AIR HANDLING SYSTEM RETRO-COMMISSIONING TRENDING ANALYSIS

AIR HANDLING UNIT TRENDS

RETRO-CX MEASURE #1

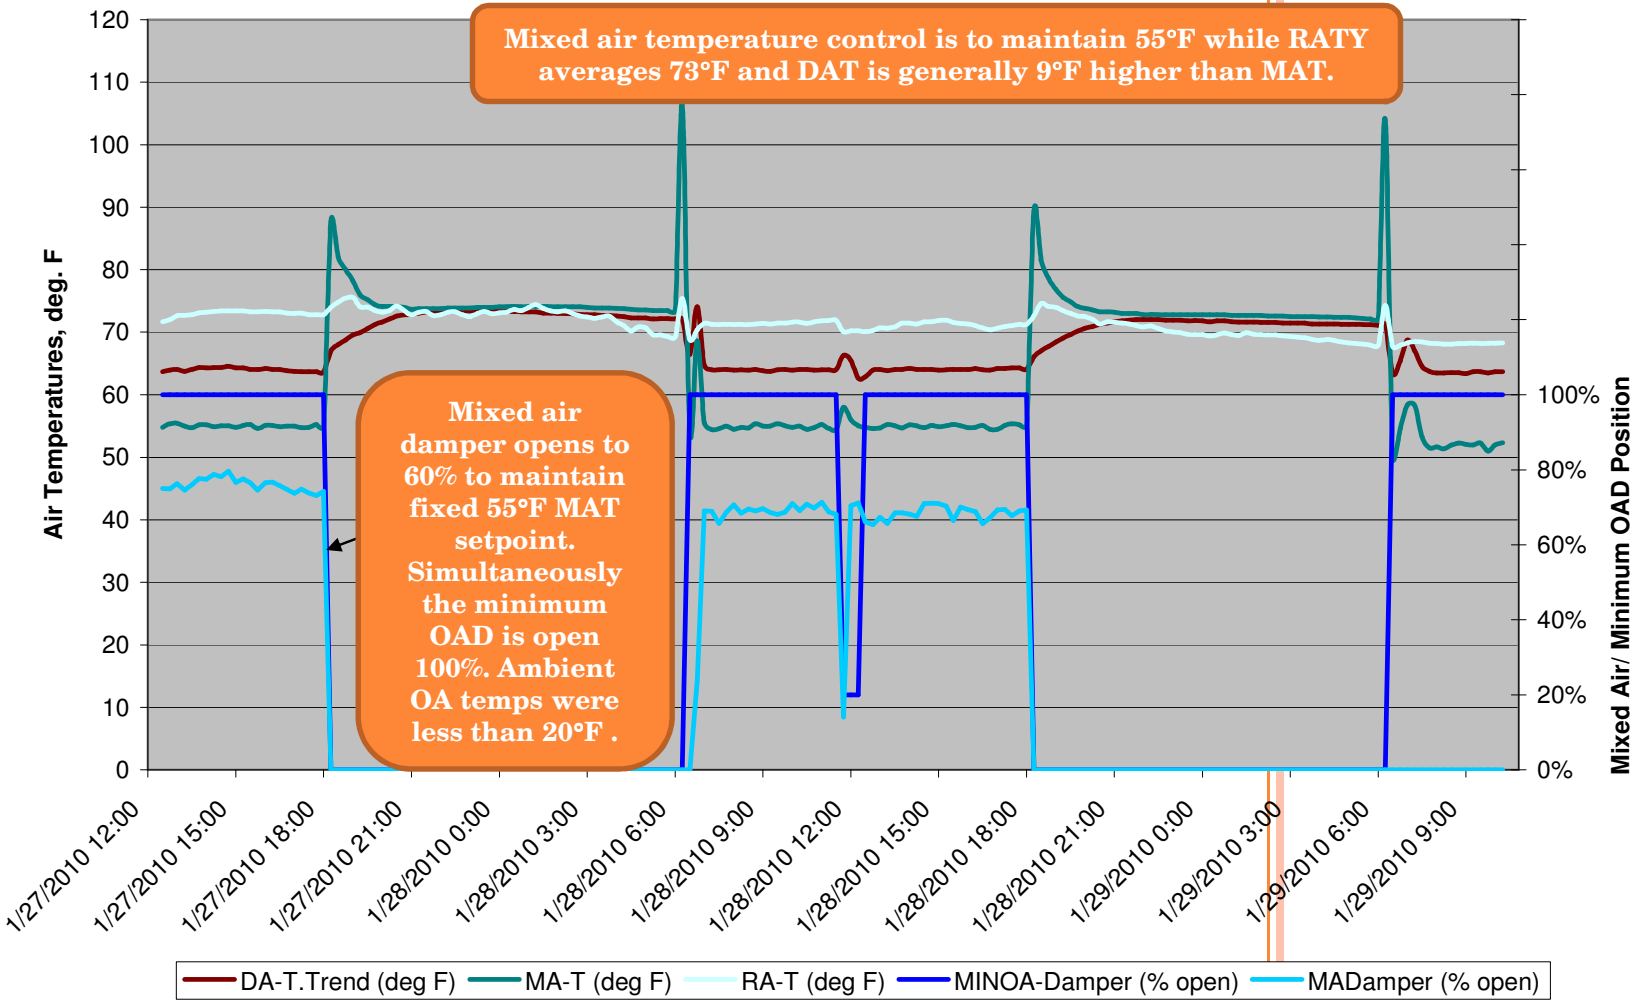
- When TEMP-ECON is ON and ENTH-ECON is OFF, the mixed air dampers modulate to maintain mixed air temperature setpoint.
- When TEMP-ECON is OFF and the ENTH-ECON is ON, the mixed air damper command is closed.
- Enthalpy control capability is not active.
- Economization control is dry bulb only
- Economization is only active from a 55°F outside air temperature and less.

- Modify economizer control to use the enthalpy comparison for economization.
- Modify the Dry Bulb control to be a comparison between RAT and OAT (less 2°F).
- Raise the economizers dry bulb setpoint from 55°F outside air temperature to 67°F.

RETRO-CX MEASURE #2

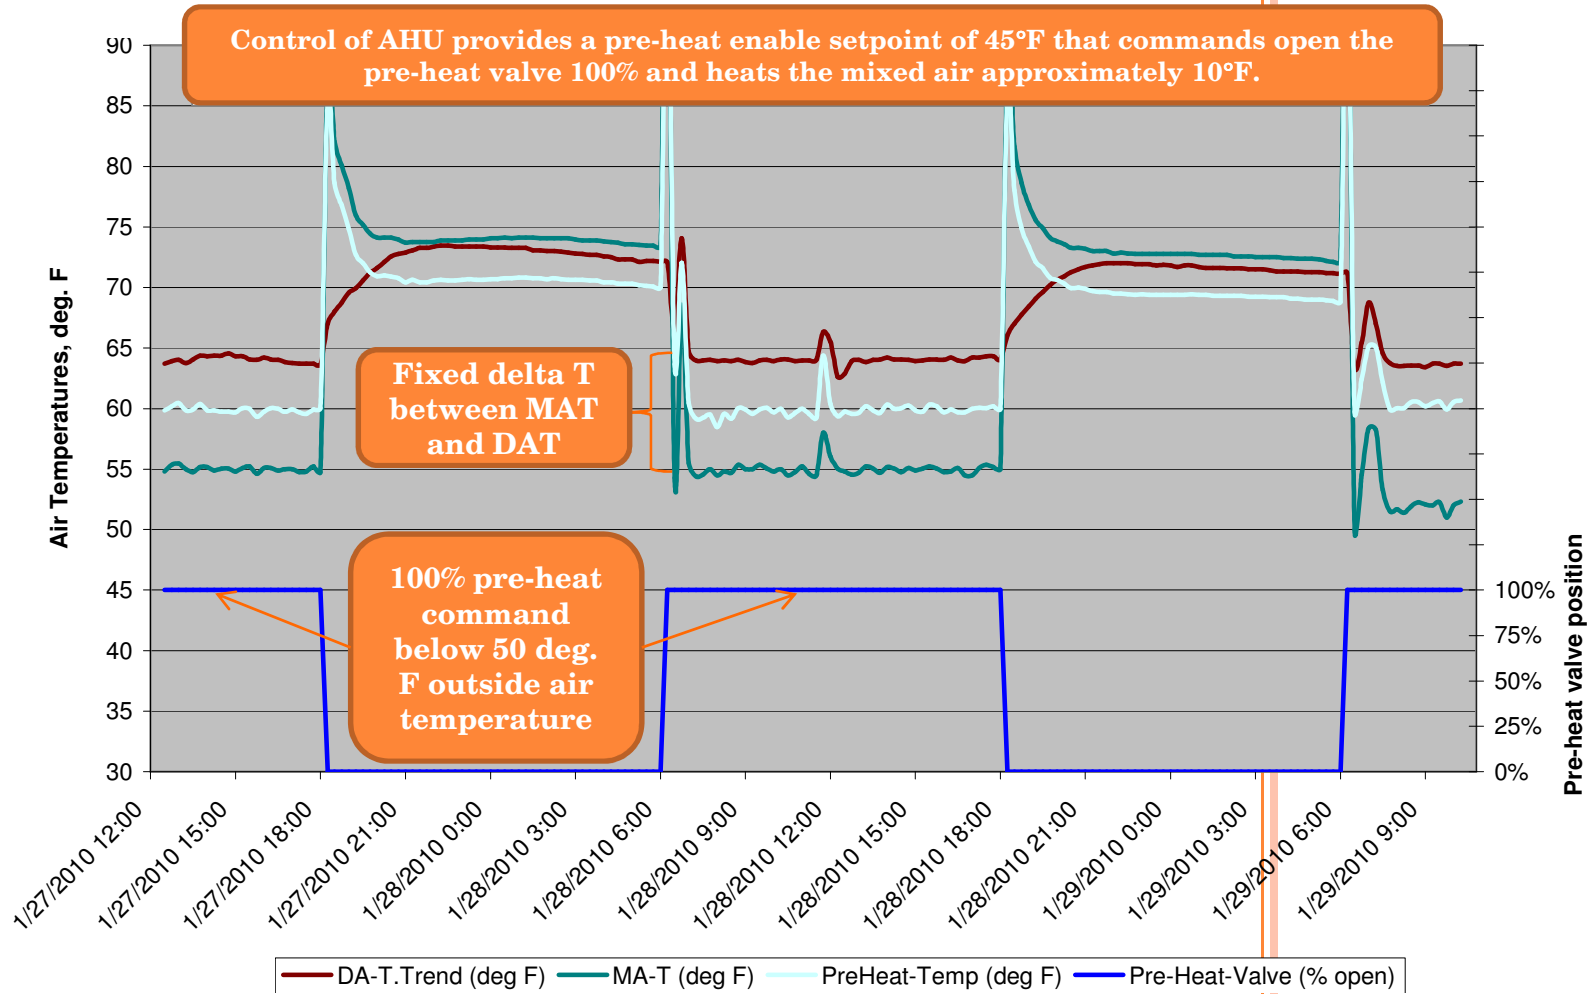
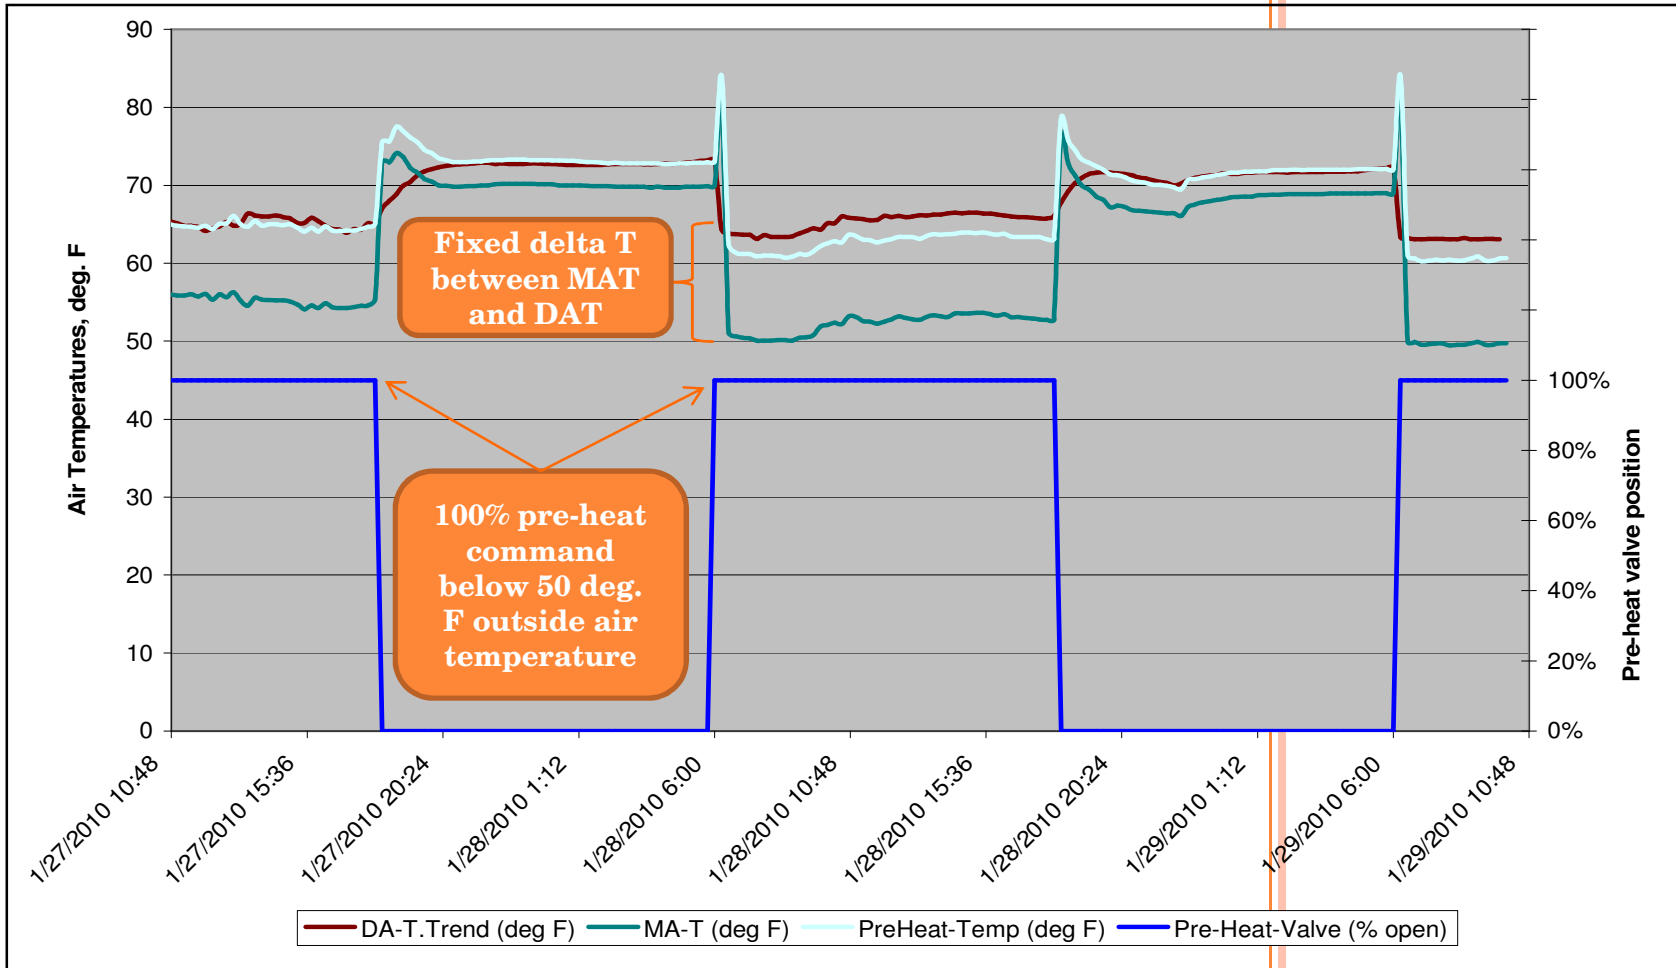
- The preheat control valve is enabled at an outside air temperature setpoint of 50°F.
- At the outside air enable temperature condition, the pre-heat control valve is commanded to a 100% open position.
- Taking control of the pre-heat valve will provide finer temperature control capability.

- Modify control sequencing to reset the pre-heat air temperature setpoint to maintain 1 deg. F below the discharge air setpoint.
- Modify the control logic to provide PID control of the pre-heat control valve.
- Reduce the pre-heat enable setpoint to 45°F.

RETRO-CX MEASURE #3

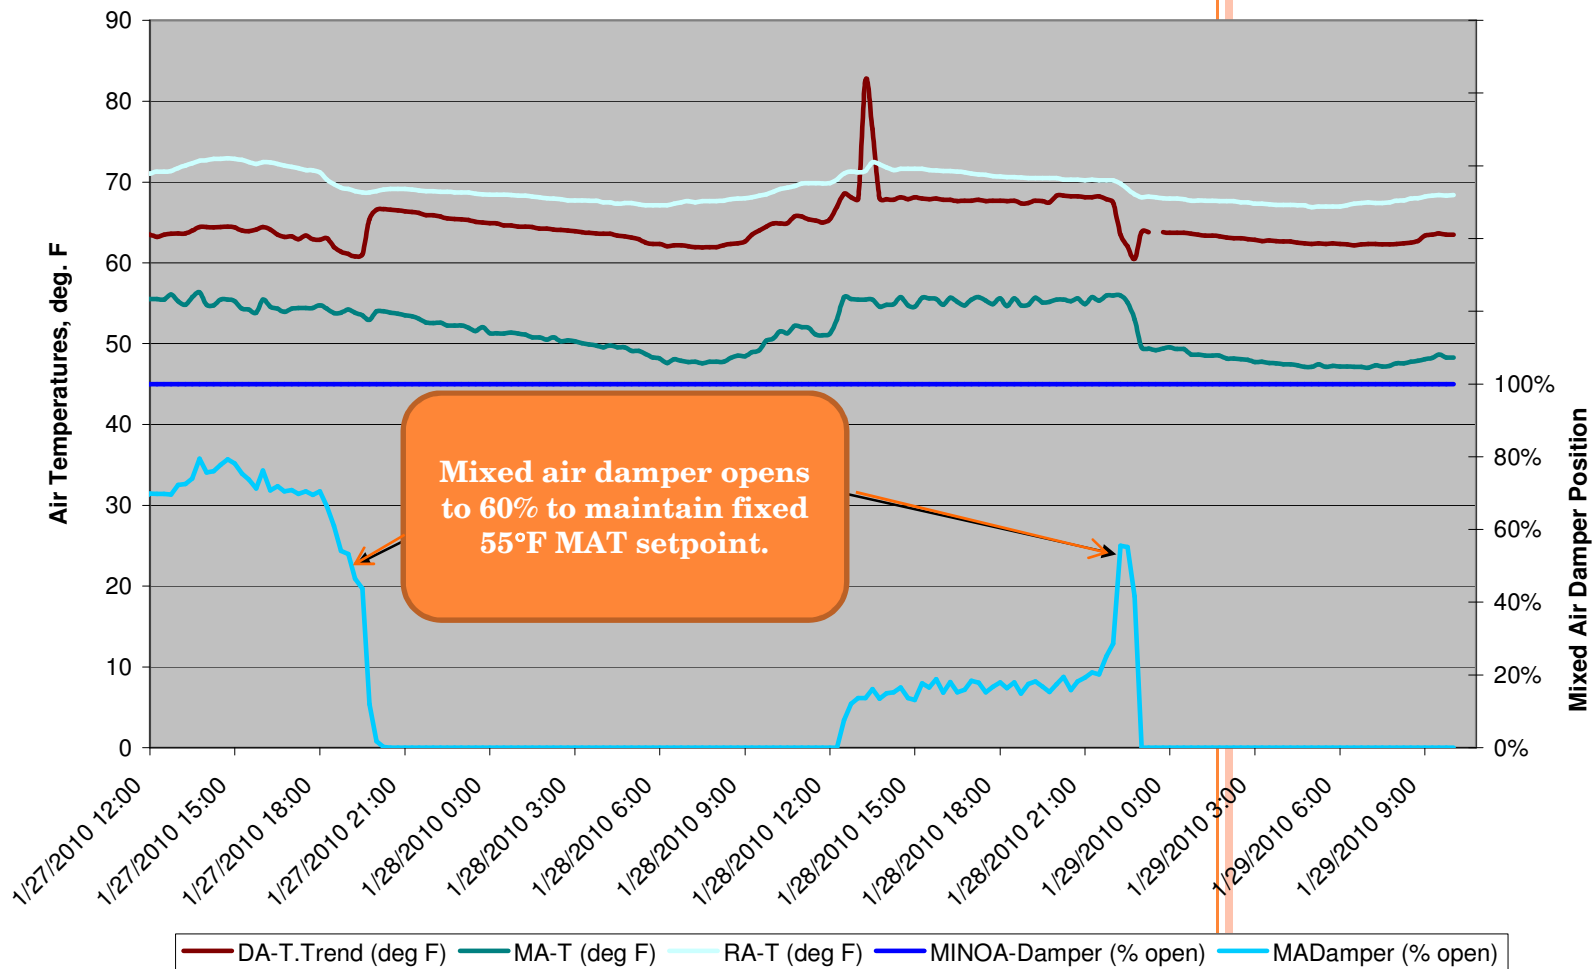
- Mixed air temperature controls to maintain 55°F while RAT averages 73°F and DAT is generally 13°F higher than mixed air.
- Mixed air damper modulates to maintain a fixed 55°F mixed air temperature setpoint
- Minimum OAD is simultaneously open to a 100%
- During the trending period the ambient outside air temperatures were generally less than 20°F.
- The fixed mixed air temperature is intended to supplement economizer control.
- A fixed mixed air temperature places an excessive heating load and unnecessary steam usage on the pre-heat coil as it gets colder outside.
- As it gets cooler outside there needs to be a means to exit economization .
- With 100% a pre-heat command on the pre-heat coil resulting in a 64°F-66°F discharge air temperature through the current inefficient pre-heat control, then it is assumed that temperature is adequate for discharge air temperature delivery.

- Provide a mixed air reset strategy to set the mixed air setpoint to be 1°F less than the discharge air temperature.
- The modified mixed air temperature setpoint should allow the mixed air damper to control and track to the discharge air temperature along with a modified discharge air reset control strategy.
- This control strategy will force the mixed air damper control to a more closed position during colder ambient conditions and reduce air handler heating loads.

RETRO-CX MEASURE #4

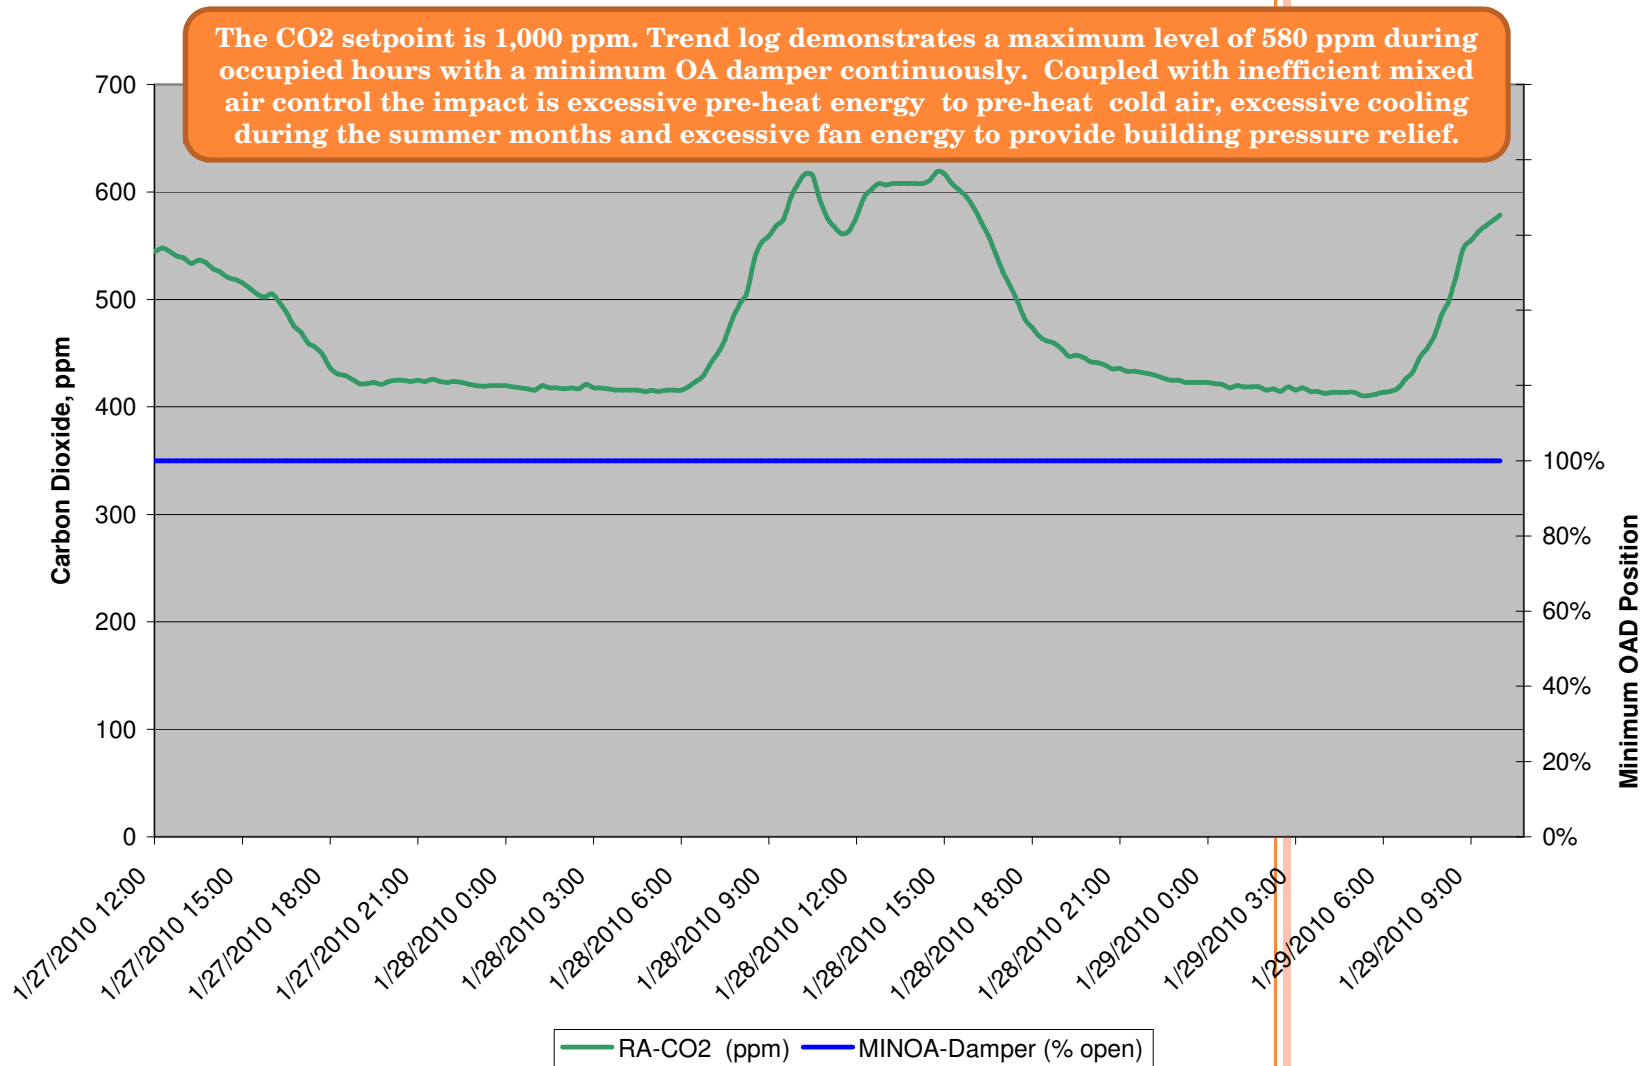
- Air handling unit(s) each have return air mounted CO₂ sensors. Trend logs and random checks show CO₂ in the order of 500-600 ppm (Occupied).
- Unoccupied CO₂ level of approximately 420 ppm.
- Metasys has a 1,000 ppm CO₂ setpoint.
- During all operating conditions, the minimum outside air damper remains 100% open.
- Based on the trend logs and visual observations, the demand control sequence of operation is inactive.
- Reductions in ventilation airflow delivery through effective CO₂ control will facilitate decreased cooling and heating loads during non-economization and mixed air modes of operation.

- Provide a functioning CO₂ control sequence that will modulate the minimum outside air damper position in order to maintain CO₂ setpoint during non-economizer modes of operation.

IMPACT OF EXCESSIVE OUTSIDE AIR ON RELIEF FAN SPEED AND POWER CONSUMPTION

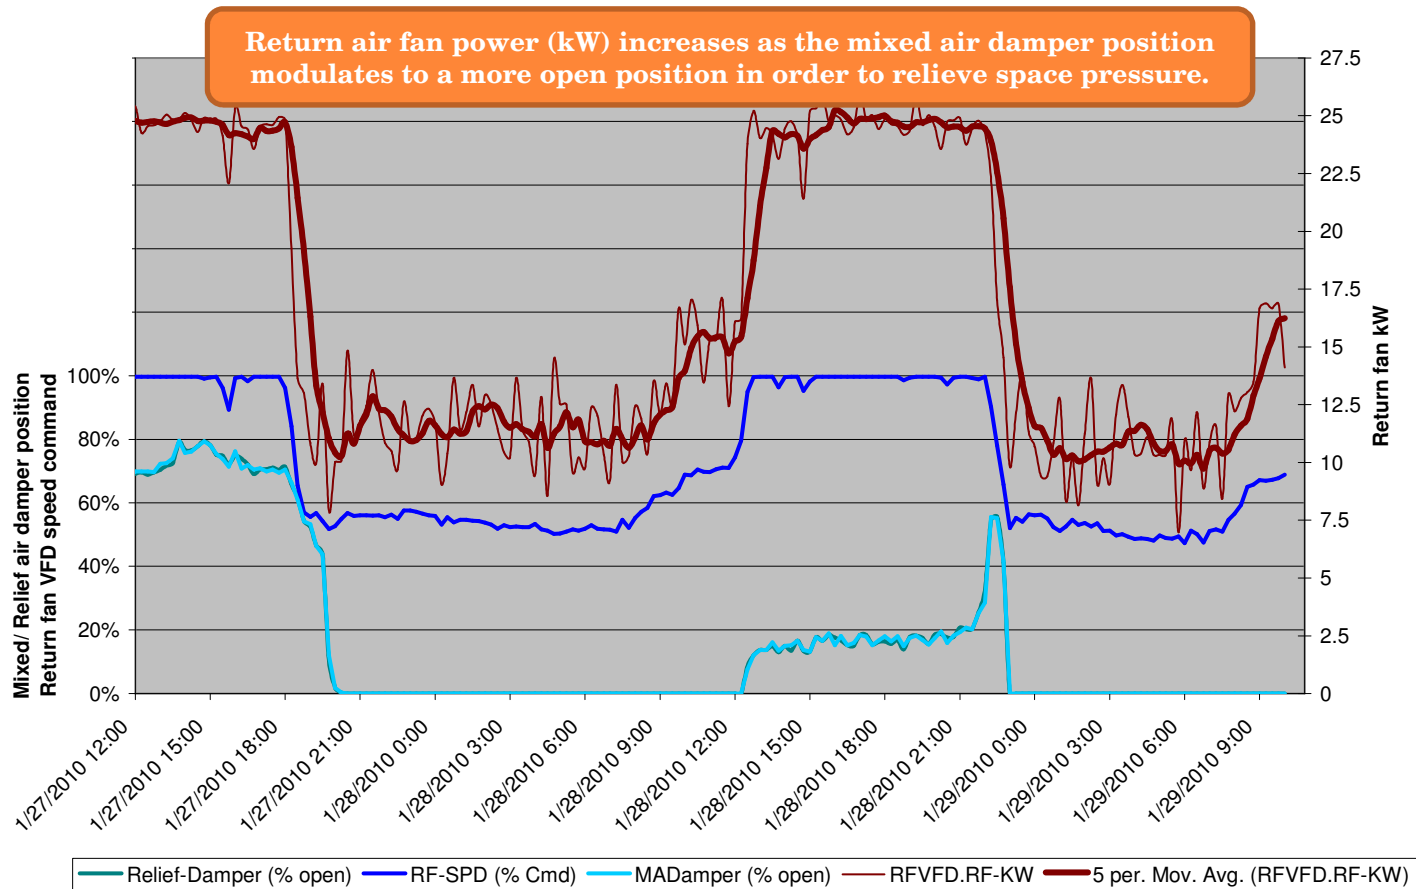
- Increased in outside air through the mixed air dampers has a direct correlation to relief fan speed and power consumption.
- Modified mixed air control as described in in Retro-Cx Measures #3 and #4.
